**From:** [Yu, Olivia, EMNRD](#)  
**To:** [LovelyTaylor, Kayla](#); [Naranjo, Mark](#)  
**Cc:** [Strang, Dana V.](#); [Martin, Ed](#); [Wells, Todd](#); [Mann, Ryan](#); [Pope, Gregory](#); [Goates, R. Neal](#)  
**Subject:** RE: 1RP-4716 - EVGSAU Satellite 3 Trunk Line Work Plan  
**Date:** Friday, July 20, 2018 2:48:00 PM

**Subject:** 1RP-4716 - EVGSAU Satellite 3 Trunk Line Work Plan

**Table 1**  
**ConocoPhillips**  
**Excavation**  
**EVLRP SAT 3**

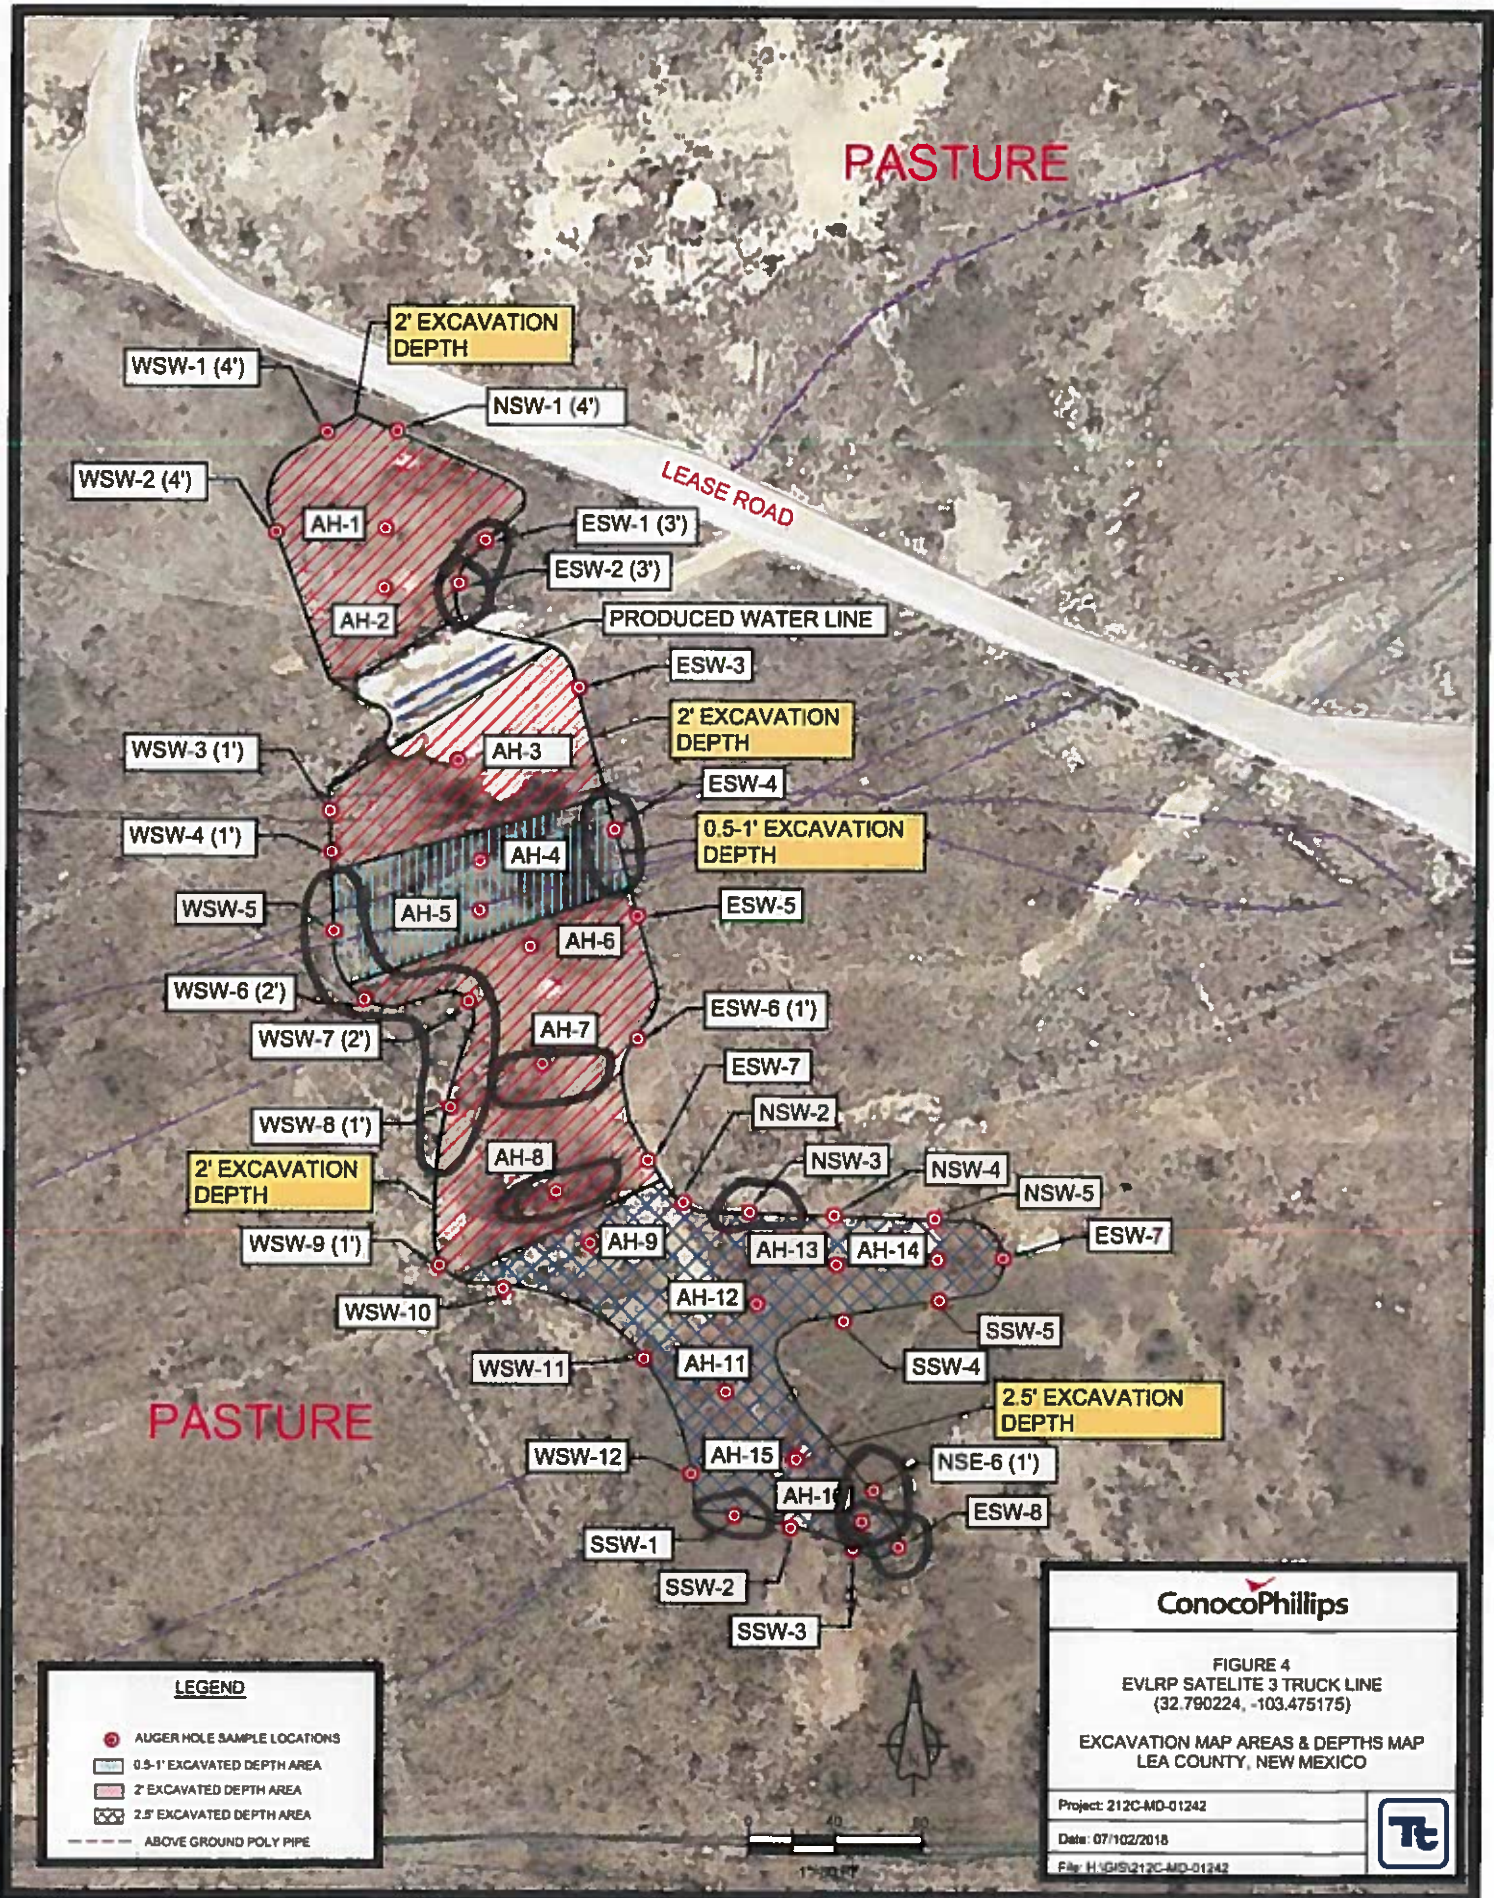
- WSW-1 & WSW-2 were labeled as taken at 4 ft. bgs on Figure 4. Does that mean that the area, represented by AH-1 and AH-2, was excavated to 4 ft. bgs? If so, please remember to update the figure in the subsequent report. Currently, this area is shaded as 2 ft. excavation.
- Please be advised that if the area represented by AH-4 and AH-5 cannot be excavated pass 0.5 ft. to address the TPH and chloride-impacted soil, 1RP-4716 will be deferred for remediation of the soil under the pipelines at a later time, even if the remainder of the release area has been resolved.

Sidewall samples exceeding TPH concentrations and recommended chloride levels were WSW-5, WSW-6, WSW-7, WSW-8, ESW-1, ESW-2, ESW-4, NSW-3, NSW-6, and SSW-1 and circled on the attached map for reference.
